DBA annotated concept views / Revision B

DBA / REV B | NOMINAL mm | CONCEPT ONLY - NOT TO SCALE

MODULE / TOP VIEW

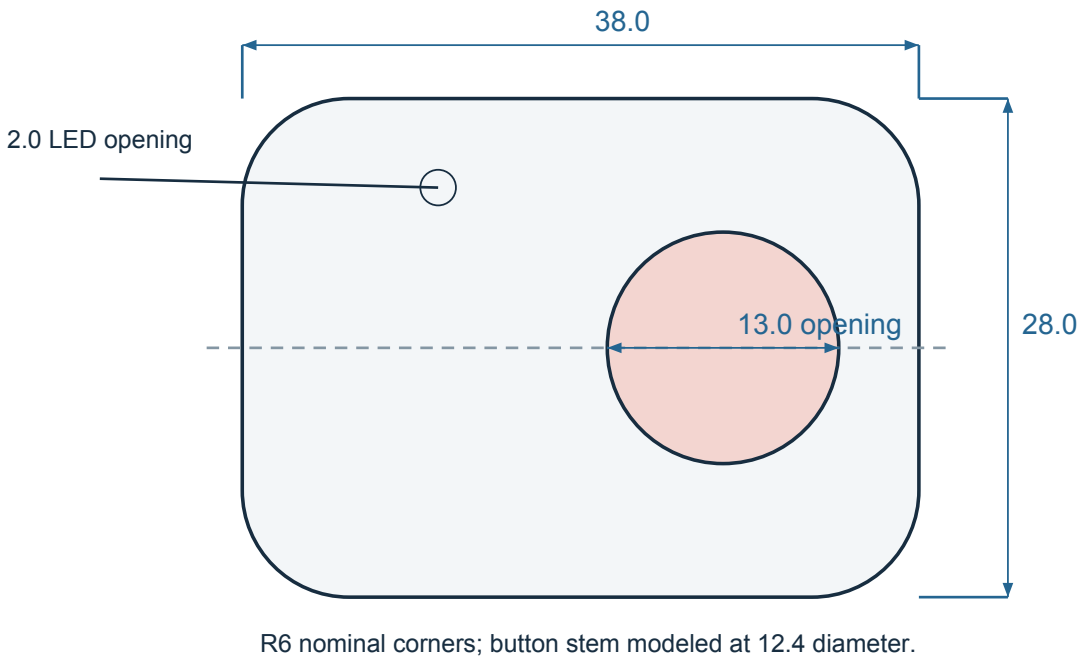
Housing envelope excludes button protrusion.

38 x 28 mm nominal housing. The 13 mm button opening is distinct from the 12.4 mm modeled stem and 16 mm flange. Housing height is 11.5 mm; button protrusion is a further 2.2 mm.

BAND / FRONT VIEW

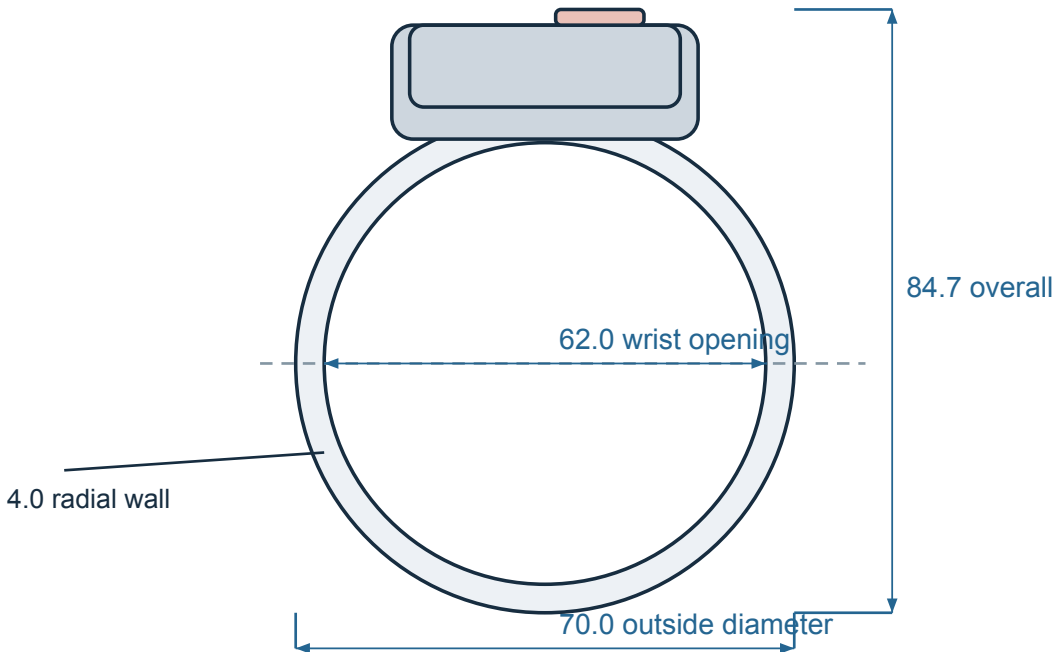
Source: original dba_cad.py and unchanged embedded geometry. Existing DBA-001 discrepancy: 88.5 mm overall versus 84.7 mm from the source. Drawings are not to scale and are not a fit or structural verification.

Existing source geometry, with the module assembled.
24.0 band width along wrist axis; 33.0 cradle width.

62 mm relaxed opening, 70 mm nominal band outside diameter, 24 mm axial band width and 4 mm radial wall. 84.7 mm overall source height includes the button. Wrist coverage and stretched fit are not demonstrated.

MODULE / SCHEMATIC SECTION

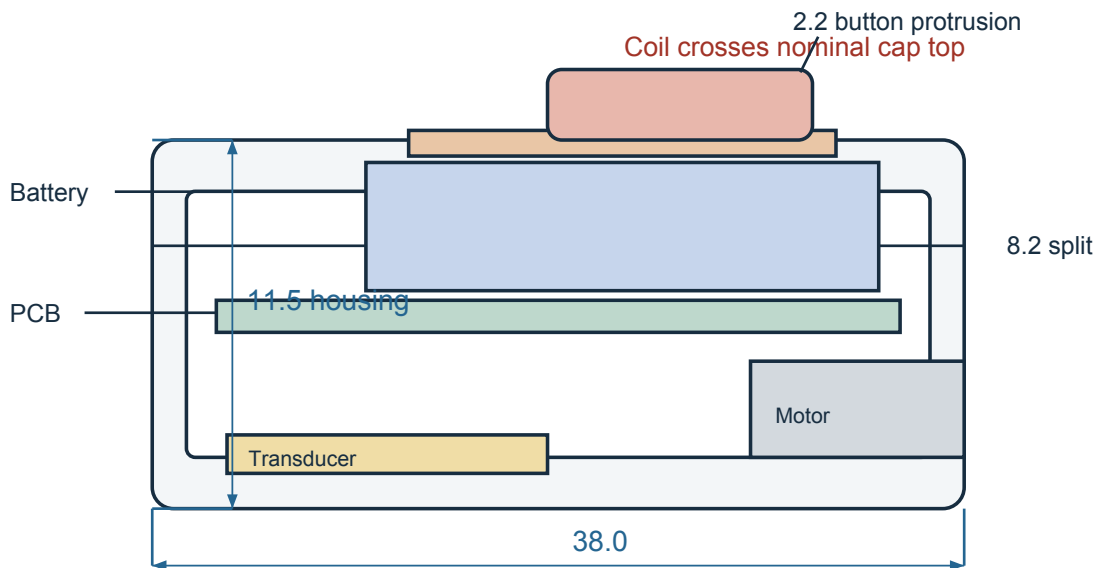
Internal packaging is unresolved. This view does not certify fit.

Cap/battery overlap, coil clearance and switch/button stack require reconciliation.

The section exposes unresolved cap, battery and coil clearances. It is an explanatory section, not a released manufacturing drawing. No tolerances, material approval or pressure rating are assigned.
